INDESIT company

Model type:
LS245EU

Commercial code:
F028177

N1045072FIG1

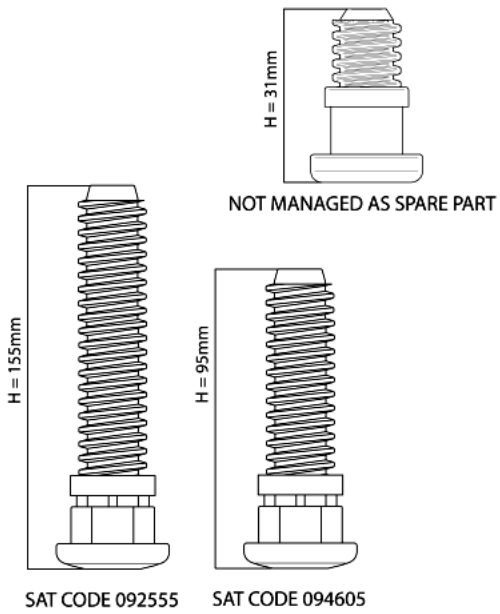
N1045072: Introduction of fixed rear foot H=31mm on free-standing models.

From serial no. 40218.0001, free-standing dishwashers affected by this modification have been equipped with new fixed rear feet (H=31mm).
The new foot replaces the adjustable one (H=155mm) Service code 092555; on the EVO3 range with TurboDry the new foot replaces the adjustable foot (H=95mm) Service code 094605.
The Spare Part Warehouse will continue to manage only 155mm and 95mm adjustable feet as they are interchangeable with the fixed 31mm foot.
The three feet are shown in illustration N1045072FIG1.

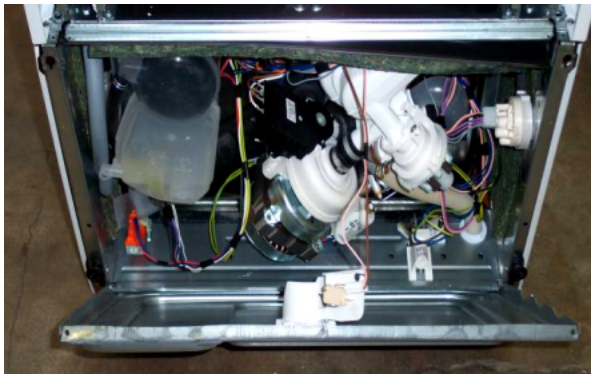
n1045062: Introduction of a new DW EVO structure

From serial number 30101.0001, all dishwasher models affected by this modification have been produced with EVO structure.
These models have been equipped with NEW TRAYS AND NEW FEET (see N1045062TAB1).

Photo N1045062FIG1 illustrates the bottom of the dishwasher with EVO structure.

Regulation assembly DX/SX Sat codes 078397 and 078396 will be managed up to stock end, after that they will be replaced by new Sat codes 092821 and092820. The same is for rear foot Sat code 078385 which will be replaced by Sat code 092822.

N1045063

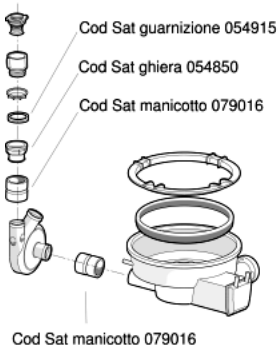
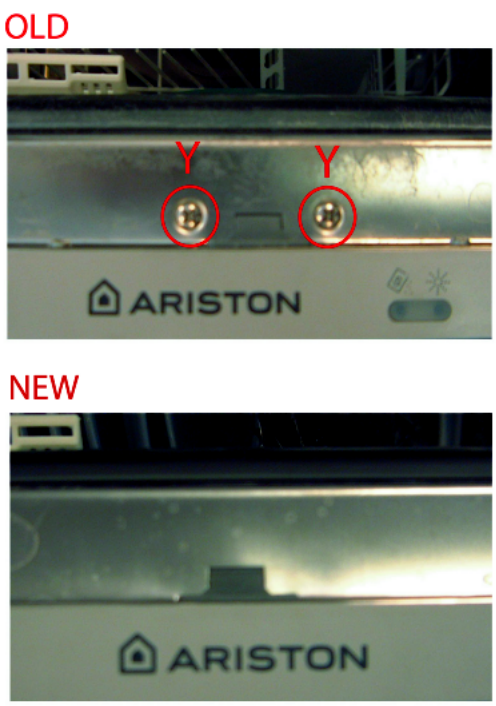
n1045063: Introduction of coupling+ring nut Sat code 093752

From serial number 30224.0001, all dishwashers affected by this modification have been equipped with the new coupling+ring nut assembly Sat code 093752, in place of coupling Sat code 079016, ring nut Sat code 054850 and gasket Sat code 054915.

Ring nut Sat code 054850 will continue to be available from the spare parts warehouse while stocks last, and coupling Sat code 079016 will continue to be stocked because it is still used for the tank-volute connection.
Picture N1045063 illustrates the premodification structure in FIG1 and the new structure in FIG2.
